AXIOM Remote	
PIC32MZ, ICSP, JTAG	
Copyright (C) 2018 H.Poetzl Licensed under CERN OHL v.1.2	remote_v0.14 4/28/20 1:26 PM Sheet: 1/4

AXIOM Remote	
Power Supply	
Copyright (C) 2018 H.Poetzl Licensed under CERN OHL v.1.2	remote_v0.14
	4/28/20 1:26 PM
	Sheet: 4/4

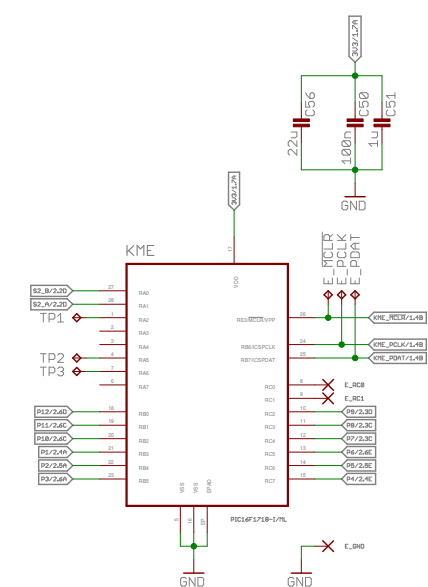
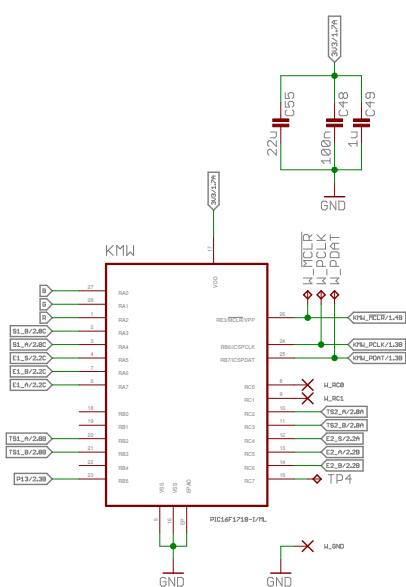
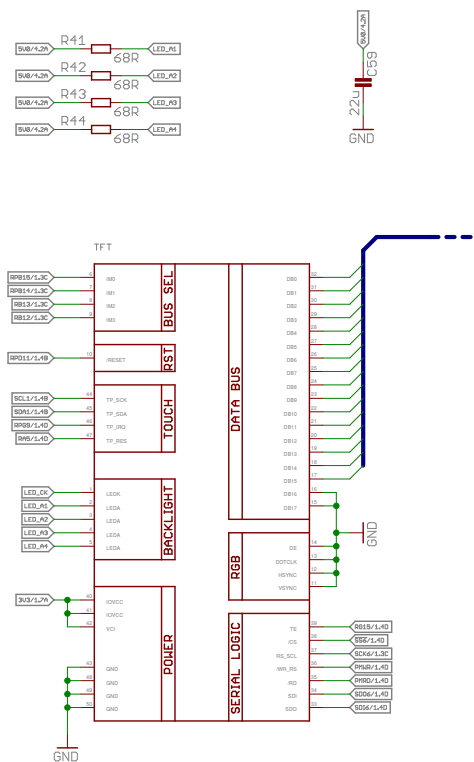
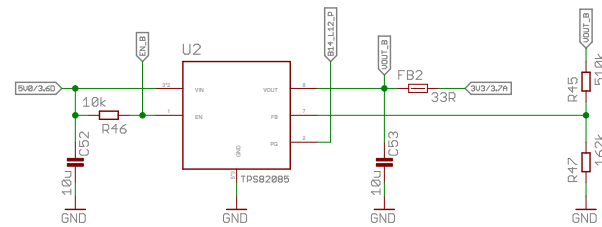
Future Modifications

Move E2 R/B to port B 18/19 for CLC?
(will probably be removed anyway)

R58 on P41/CLC capable port?
R56 on separate CLC capable ports?

Make R37-R39 0402?
not enough power?

Use P1CL05/18 1/10 instead of 1/10L?
ground I/O problems?
